QUALITY ASSURANCE -- NON-CONFORMANCE REPORT

Subject: NCR No. ZPMC-0538

Job Name: SAS Superstructure

QUALITY ASSURANCE -- NON-CONFORMANCE REPORT

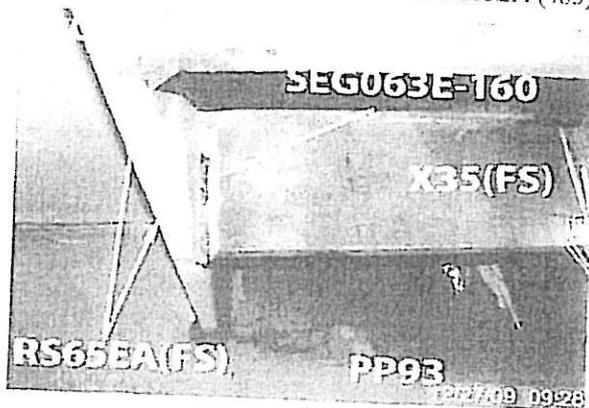
During a random in process inspection of Orthotropic Box Girder (OBG) segment 10CW, this Caltrans Quality Assurance (QA) Inspector observed ZPMC welding personnel performing Flux Cored Arc Welding (FCAW) weld repairs using a filler metal not specified on the applicable WPS.

-The repair was being performed to WPS-345+485-FCAW-3G(3F)-Repair.

-The WPS specifies the use of filler metal brand K-71TSR.

-The welder was using filler metal brand Supercored 71H.

-The weld joint is a Complete Joint Penetration (CJP) identified as SEG-063E-160 near Panel Point (PP) 93.

-The weld being repaired is joining material grades A709 Grade 345 to A709 Grade 485.

-The weld is joining parts identified as RS65EA (485) to X3S (345).

Remove said weld and replace using appropriate filler material.

Contractor replaced said weld with K-71TSR filler metal and provided NDT documentation verifying the weld is in compliance with Contract specifications.
